FAMILY VISITATION CENTER

ADA ACCESS COMPLIANCE ASSESSMENT

231 D STREET, EUREKA CA
(COUNTY LEASED FACILITY)

COUNTY OF HUMBOLDT, CALIFORNIA

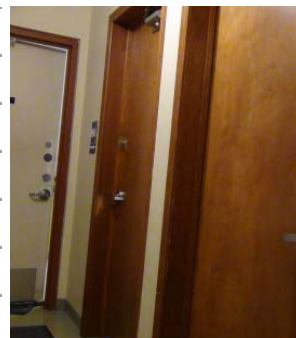
As Built Description: Device not provided

Proposed Solution: Provide strobes in common use area

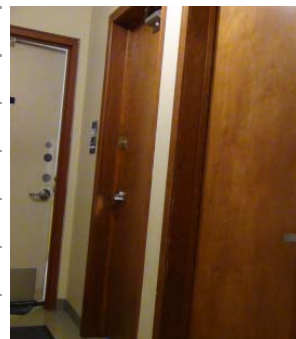
As Built Description: Tactile sign provided

Proposed Solution: Barrier removed

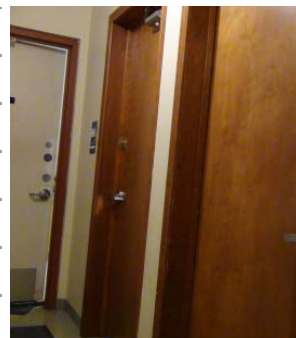
As Built Description: Raised lettering less than 5/8" high

Proposed Solution: Provide compliant sign

Field Date: 10/29/2019 Report Date: 10/29/2019 Barrier #: 10G

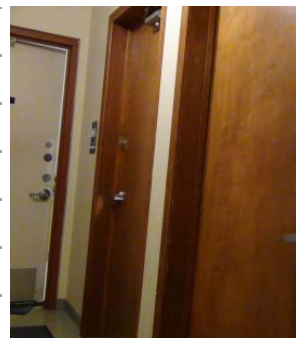
Code References: CBC Figure 11B-404.2.4.1 and 2010 ADAS 404.2.4.1
